NEW MEXICO OIL CONSERVATION DIVISION

Apache 25 Fed. #8
30-015-33439

Devon Energy
(234728)

RE: Form C-108, Application for Authorization to Inject
Apache 25 Federal #8; API# 30-015-33439
Eddy County, NM
Section 25, T22S, R30E

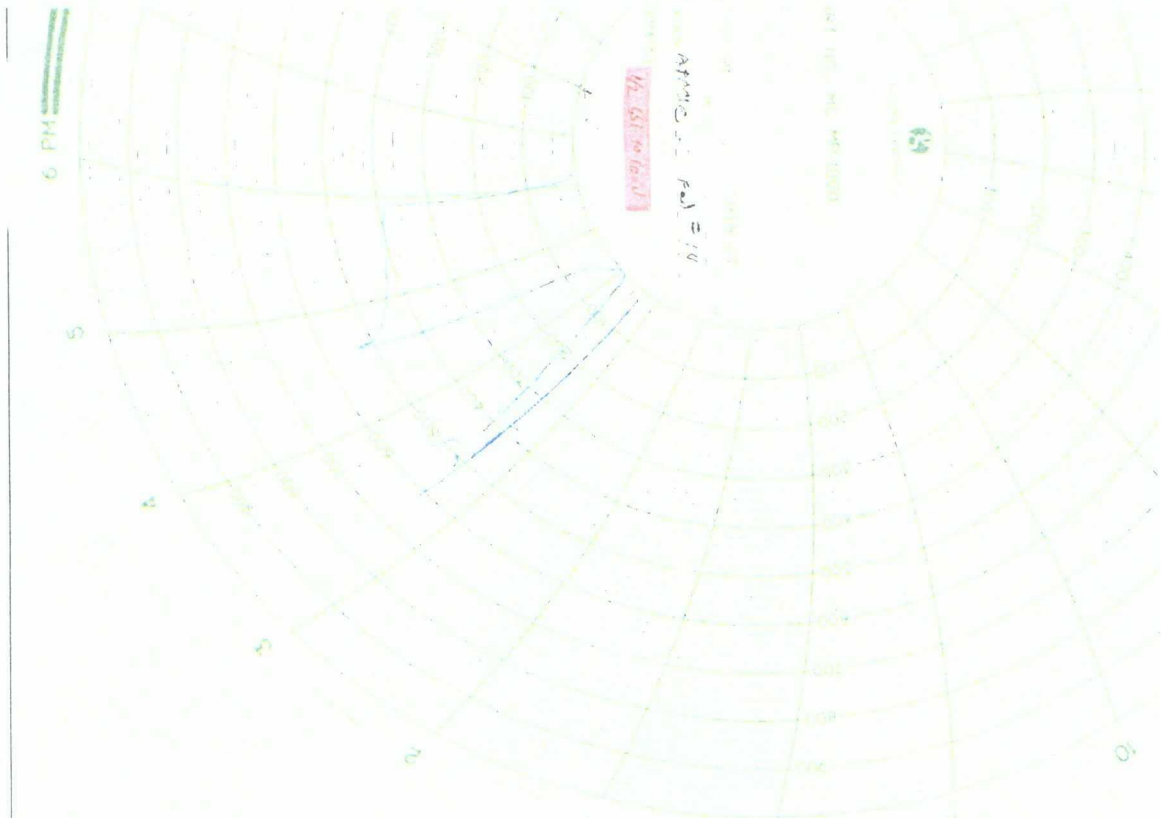
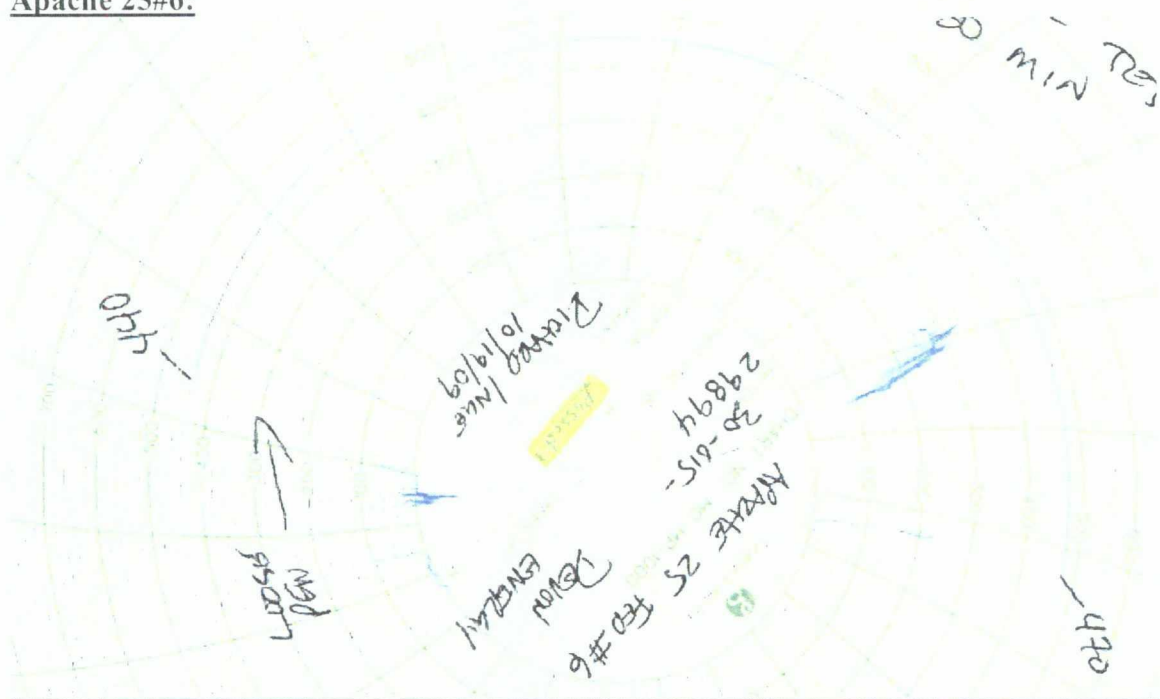
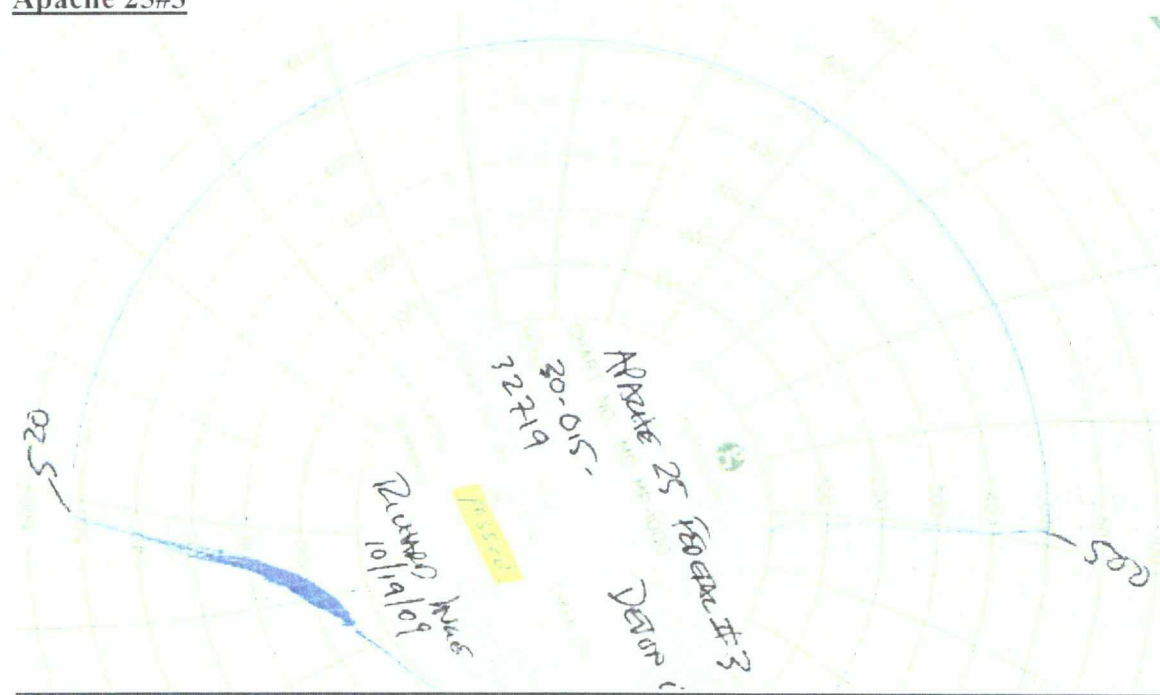
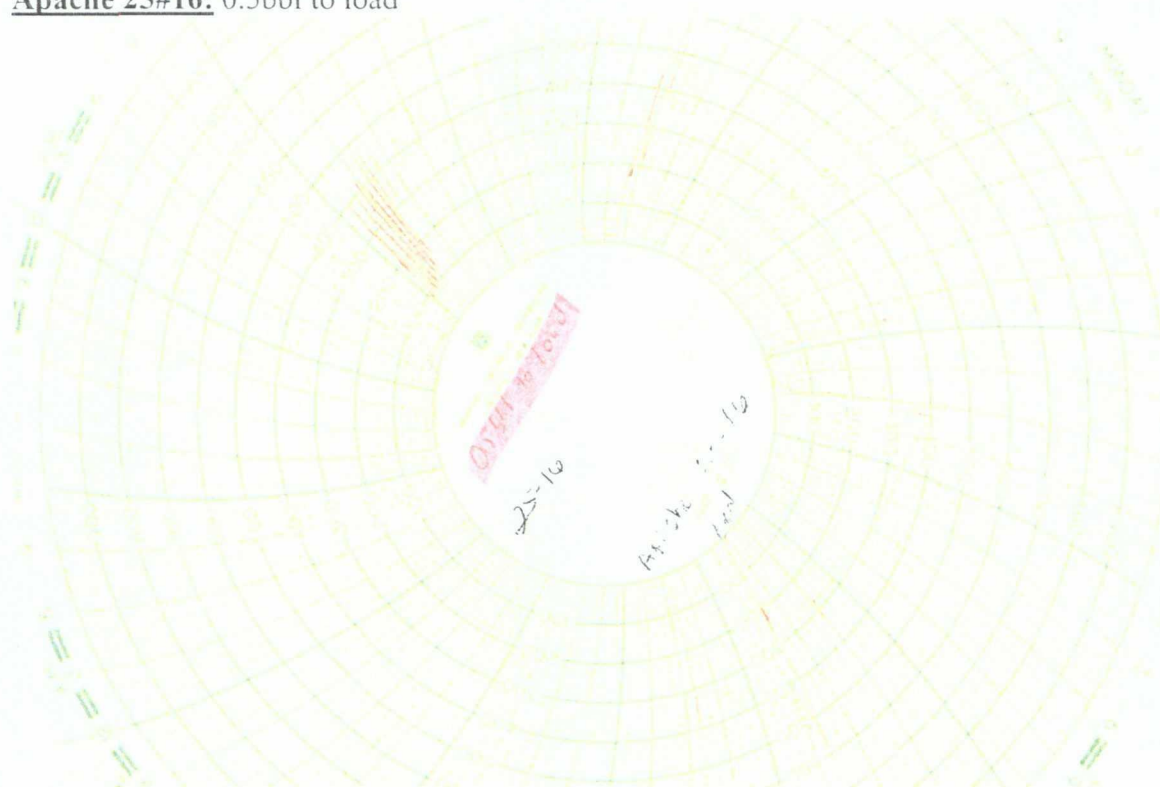
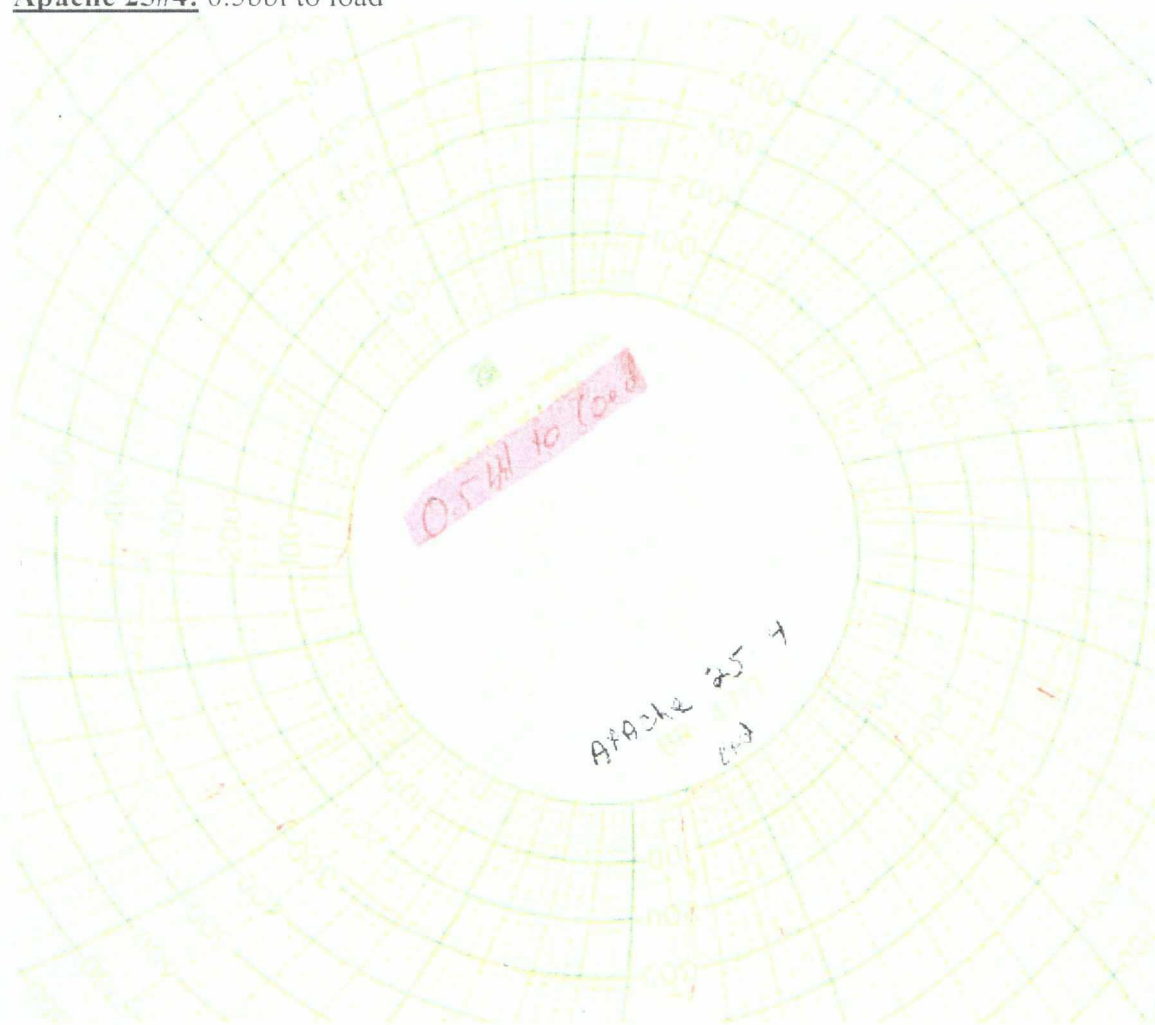
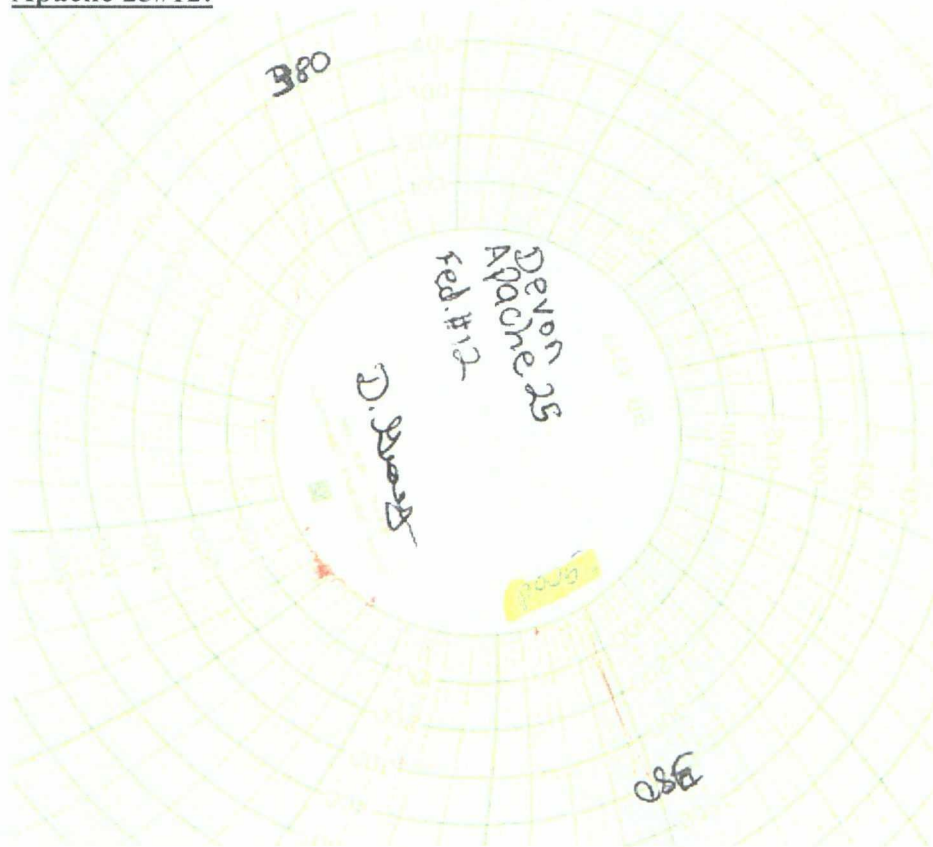
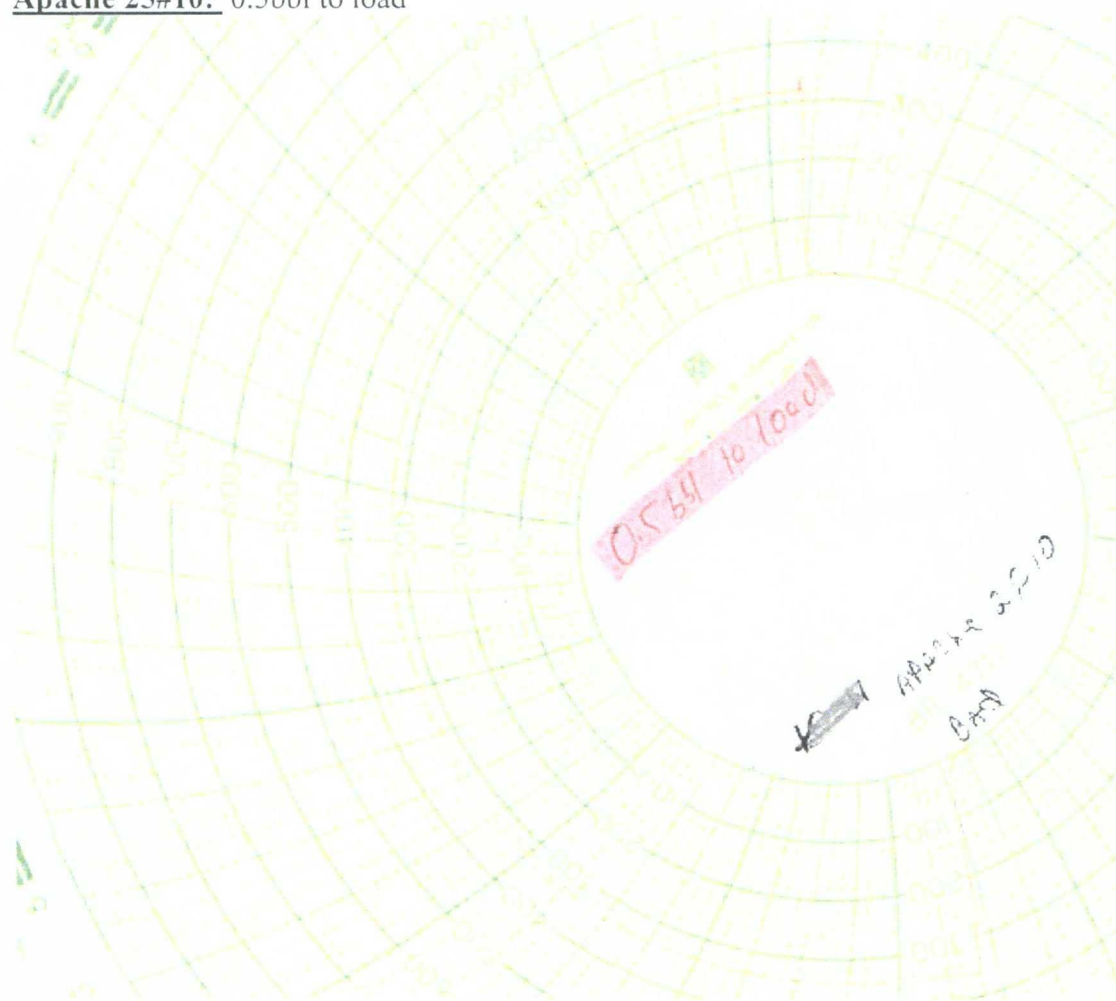
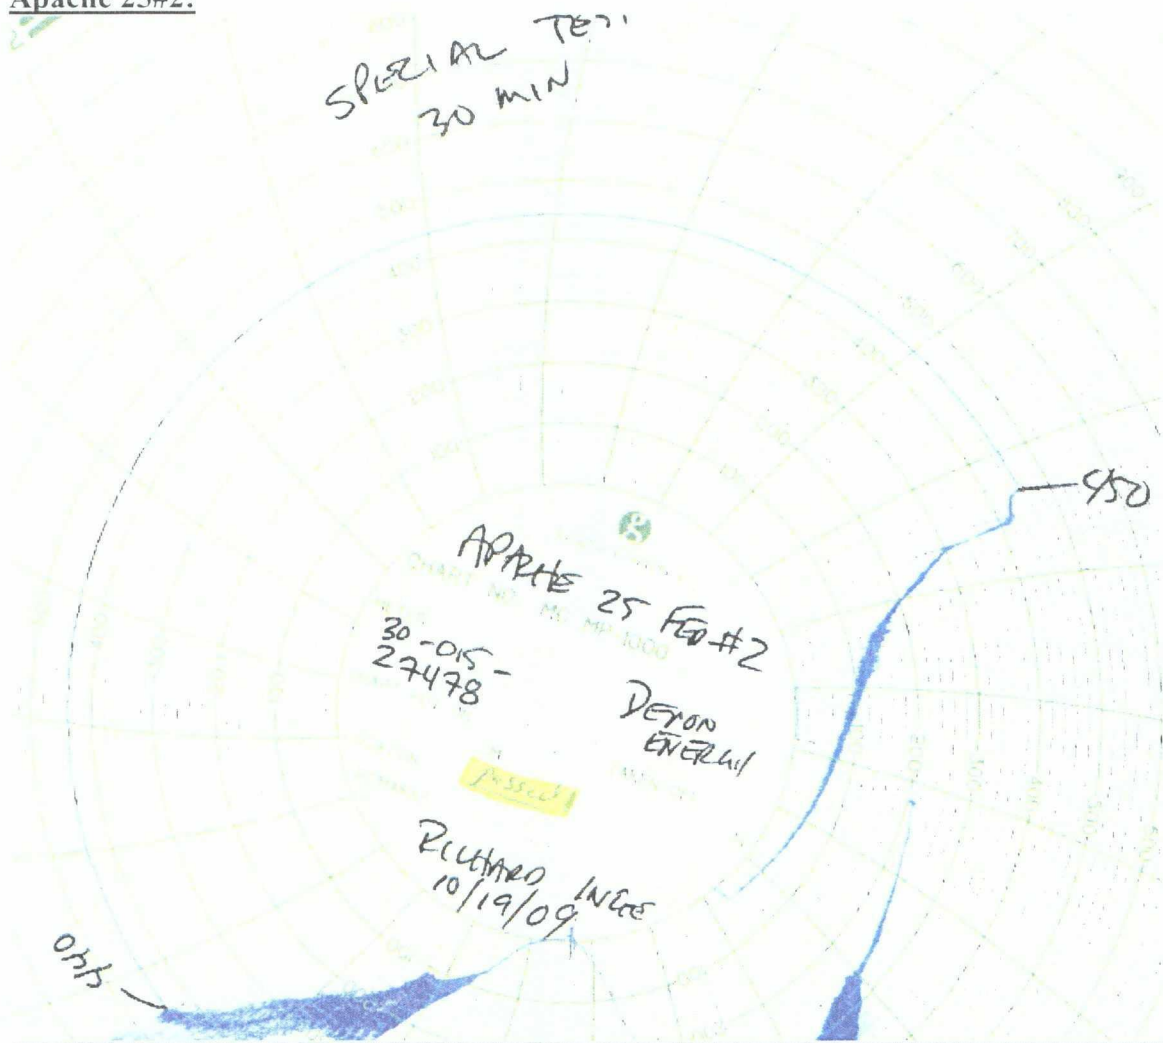
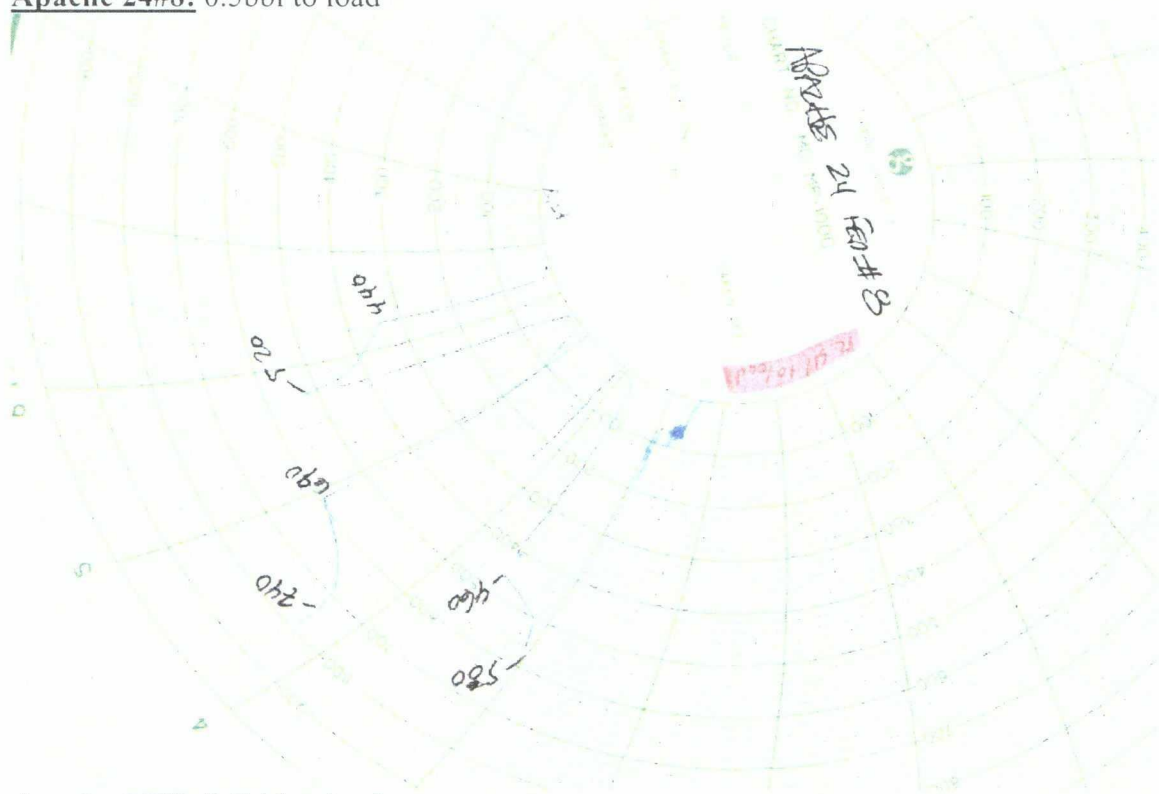
d. Would you send Bradenhead surveys and/or pressure tests on all intermediate-production casings within AOR to verify the cement top on production pipe is into the intermediate casing shoe and to verify there are no bradenhead flows. Please call our Artesia OCD office and ask if they wish to witness this work.

Here are the tests we received back from the field. I tried my best to scan these so that they were readable. If you enlarge the picture they seem to show up better. I didn't want to brighten the lines up, as to alter the data in anyway.
